**B.M.C. SERVICE LTD.
COWLEY, OXFORD**

INDEX TO

IMPROVEMENTS AND ALTERATIONS

AUSTIN SEVEN

STEERING WANDER

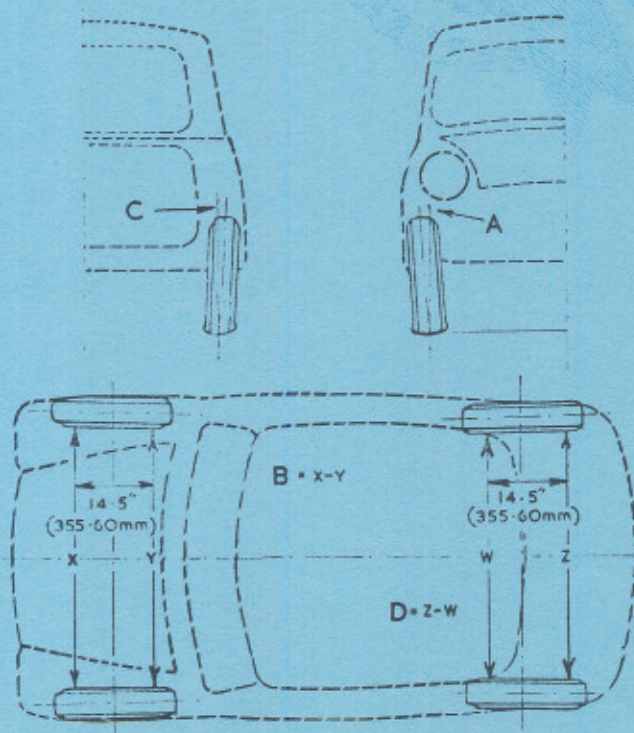
Complaints of steering wander prior to Car No. 11670 RHD or 10530 LHD may usually be disposed of by increasing the caster angle from $1\frac{1}{2}^{\circ}$ to $3^{\circ} \pm \frac{1}{2}^{\circ}$.

This is achieved by fitting a pair of the shorter tie-rods. Part No. 21A263, which were introduced at the above Car No. and which must now be used for all service replacements (PAU/826 refers).

Front wheels (A) Camber angle 2° positive $\pm 1^{\circ}$

(B) Toe OUT $1/16''$ (1.6 mm.)

Rear wheels (C) Camber angle 1° positive $\pm \frac{1}{2}^{\circ}$

(D) Toe IN $\frac{1}{8}''$ (3.2 mm.) $\pm \frac{1}{8}''$ (3.2 mm.)

INADEQUATE DEMISTING

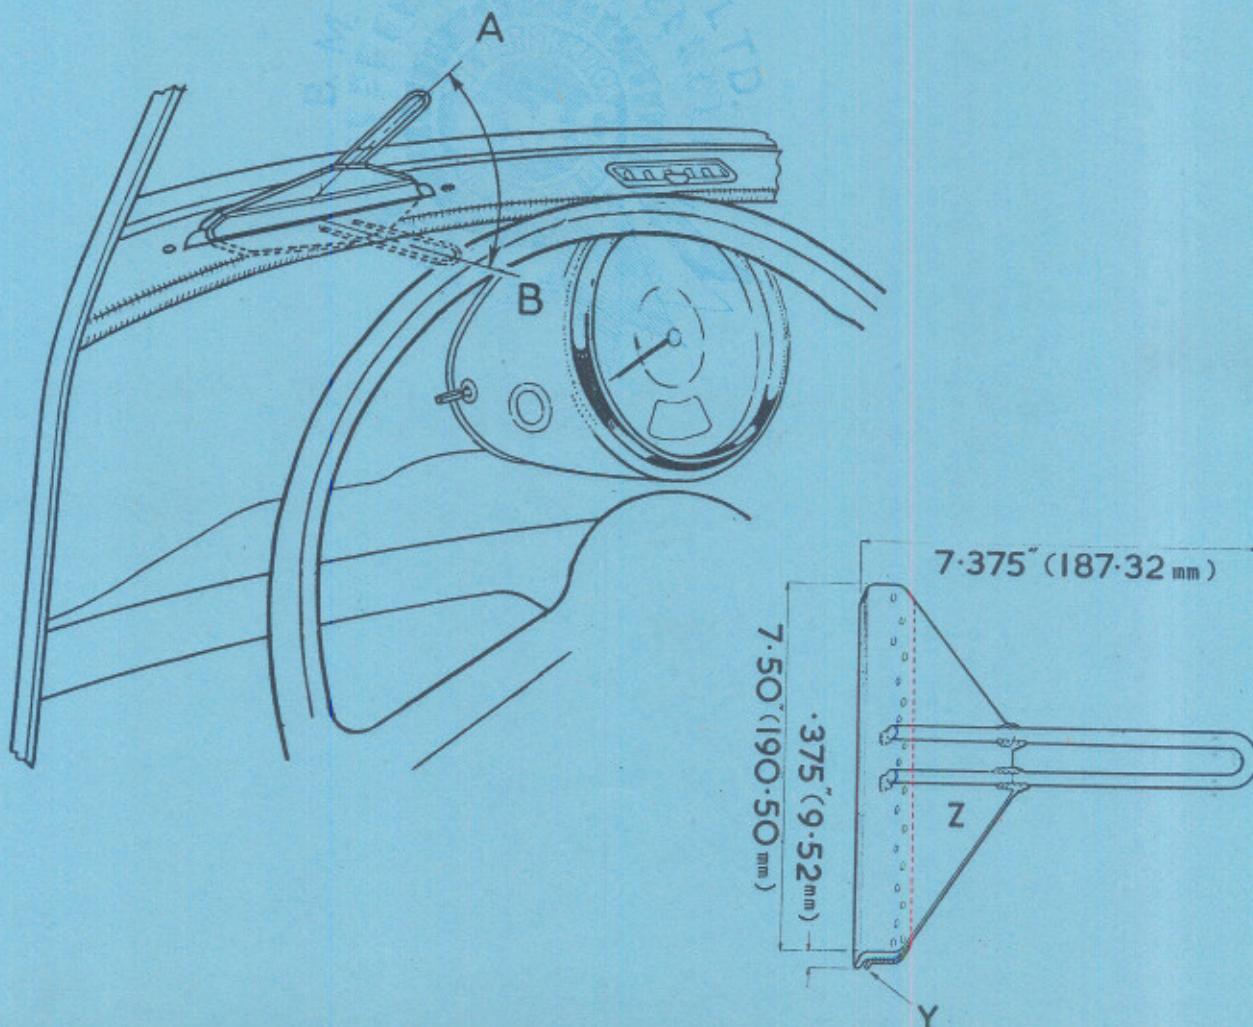
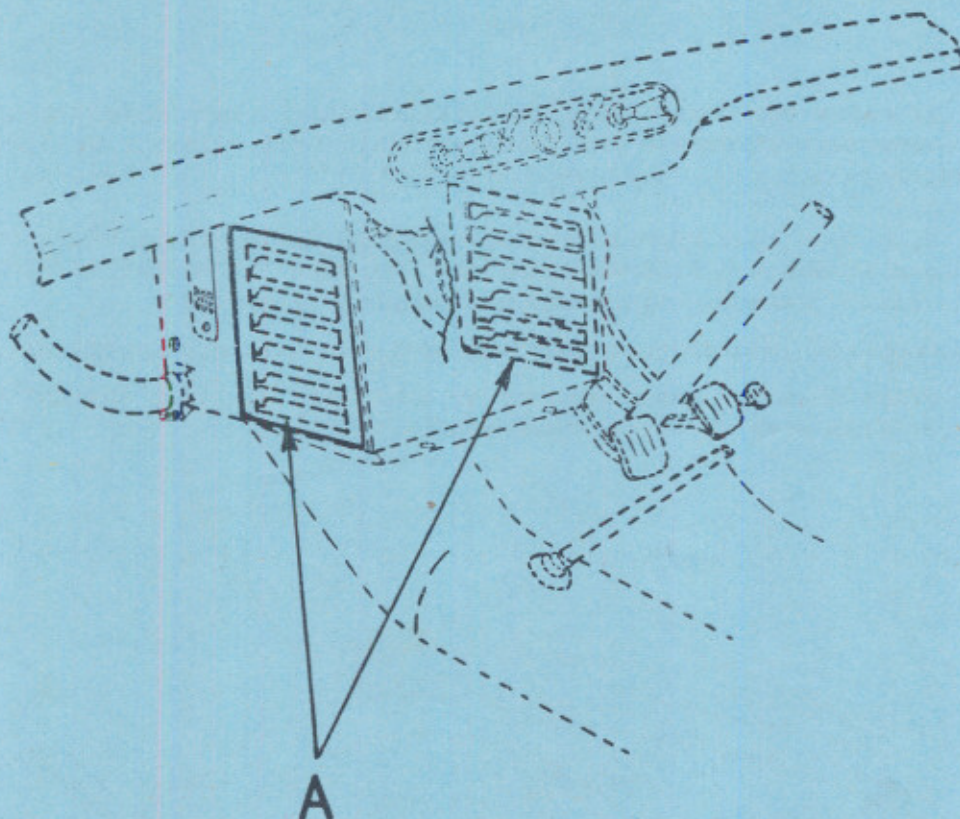
In cases where demisting is unsatisfactory, the following operation is recommended to enable air to be directed over a larger area of the windscreen:

1. Make up a tool of mild steel, using 10 S.W.G. (3.25 mm.) for 'Z' and 13 S.W.G. (2.33 mm.) for jaw 'Y' which is welded to 'Z' as shown. Take care to round and smooth all edges.
2. Position jaws of tool over the demister shield in position 'A'.
3. Press down on handle of tool to position 'B', i.e., approximately in line with steering wheel rim.

Demisting of the windscreen can be further improved if the heater louvres 'A' are blanked with 4" x 2" (say, 100 x 50 mm.) black water-proof adhesive tape.
